UNITED STATES  
NUCLEAR REGULATORY COMMISSION  
WASHINGTON, D.C. 20555-0001

SUBJECT: DIABLO CANYON POWER PLANT, UNITS 1 AND 2 - ISSUANCE OF  
AMENDMENTS RE: REVISION OF REACTOR COOLANT SYSTEM (RCS)  
MINIMUM FLOW SPECIFIED IN TECHNICAL SPECIFICATION 3.4.1, "RCS  
PRESSURE, TEMPERATURE, AND FLOW DEPARTURE FROM NUCLEATE  
BOILING (DNB) LIMITS" (CAC NOS. MF6731 AND 6732)

SAFETY EVALUATION BY THE OFFICE OF NUCLEAR REACTOR REGULATION  
RELATED TO AMENDMENT NO. 226 TO FACILITY OPERATING LICENSE NO. DPR-80  
AND AMENDMENT NO. 228 TO FACILITY OPERATING LICENSE NO. DPR-82  
PACIFIC GAS AND ELECTRIC COMPANY  
DIABLO CANYON POWER PLANT, UNITS 1 AND 2  
DOCKET NOS. 50-275 AND 50-323

Figure 2.1.1-1  
REACTOR CORE SAFETY LIMIT

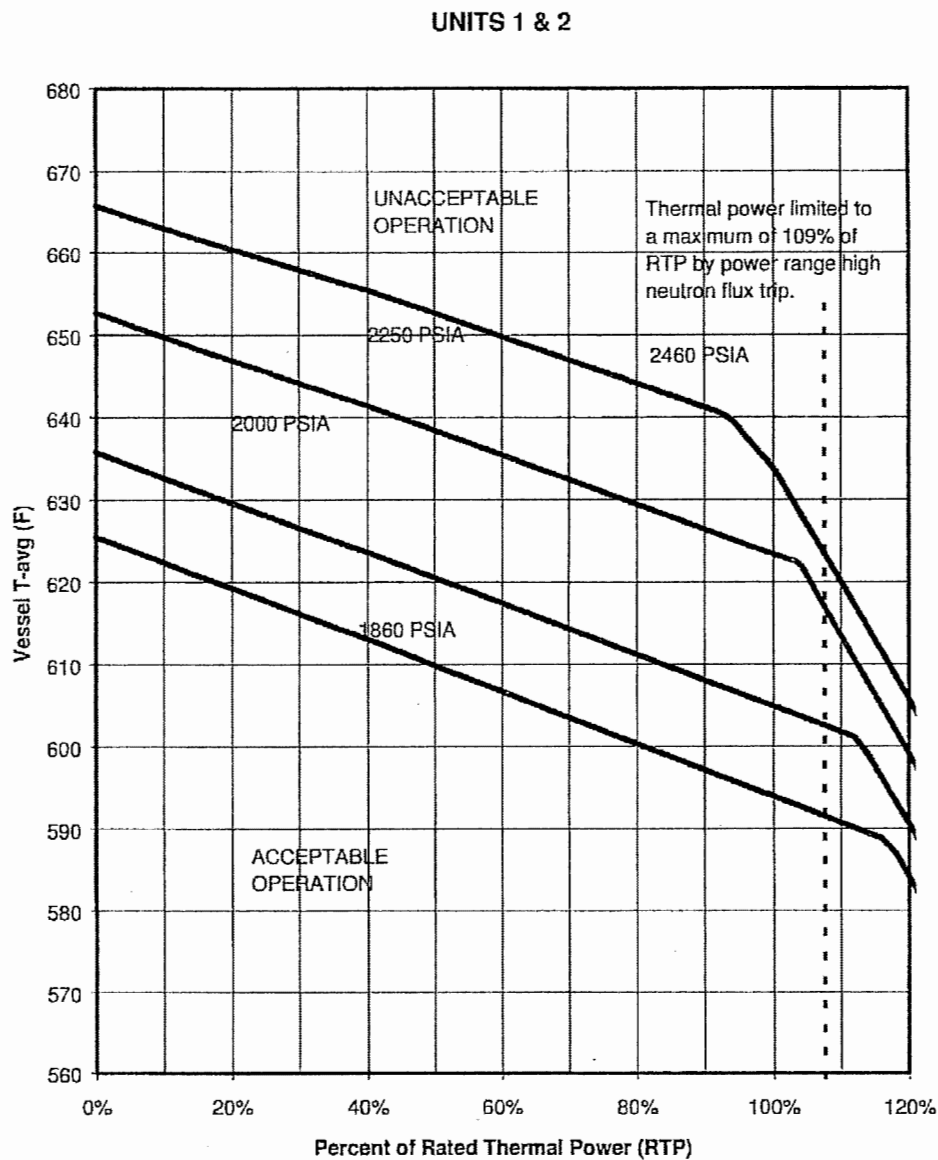
#### Figure 2.1.1-1

Current Figure 2.1.1-1 has the following footnote:

When operating in the reduced RTP [rated thermal power] region of Technical Specification LCO 3.4.1 (Table 3.4.1-1 for Unit 1 and Table 3.4.1-2 for Unit 2) the restricted power level must be considered 100% for this Figure.

The footnote makes a reference to Tables 3.4.1-1 and 3.4.1-2, which are being deleted. Hence, the footnote is no longer applicable and is being deleted.

The licensee is proposing the removal of TS Tables 3.4.1-1 and 3.4.1-2, as well as a footnote in Figure 2.1.1-1 that references the aforementioned tables. The licensee explained that the tables were previously needed to implement a less-restrictive minimum RCS flow value at powers between 90 percent and 100 percent. This was due to deficiencies in the calorimetric method by which the licensee was determining the RCS flow under some conditions. The licensee indicated that DCP, Units 1 and 2, now solely relies on the elbow tap method to determine RCS flow, so the relaxed RCS minimum flow limits at lower powers are no longer necessary. The footnote in Figure 2.1.1-1 clarified that when operating in the power-flow region defined by Tables 3.4.1-1 and 3.4.1-2, then for purposes of determining the acceptable operating vessel T-avg for a given pressure based on this figure, the power level must be assumed to be at 100 percent. Since this power-flow region will no longer be available for use by DCP, Units 1 and 2, this footnote no longer applies.

The removal of Tables 3.4.1-1 and 3.4.1-2 is more conservative because it removes the option of relaxing the minimum RCS flow at powers between 90 percent and 100 percent. Therefore, the NRC staff concludes the proposed deletions to be acceptable.
